CITY OF SOMERVILLE, MASSACHUSETTS
JOSEPH A. CURTATONE
MAYOR
OFFICE OF STRATEGIC PLANNING AND COMMUNITY DEVELOPMENT

MEMORANDUM

To: Sara Lewis, Director of Planning and Zoning
From: Division of Public Space & Urban Forestry (PSUF)
CC:
Date: May 4, 2020
RE: Edge Assembly Civic Space MSPS

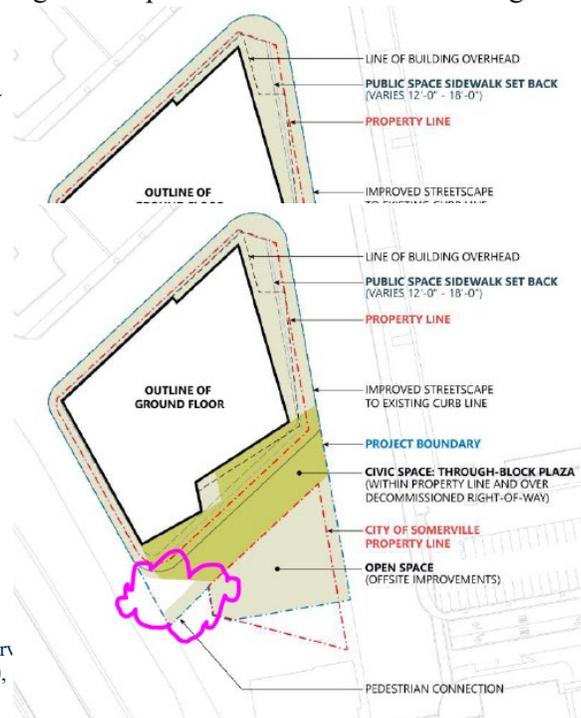
Lastly, the PSUF team is supportive of the Edge development pledging to take on Civic Space maintenance in perpetuity and have concerns about an unclaimed triangle of off site open space, that left unmaintained will detract from the gateway concept and become unruly, unkempt, and not plowed in winter if not adopted by the Edge development. We recommend the Edge development include this off site space in their proposed development. Please see location bubbled in magenta below:
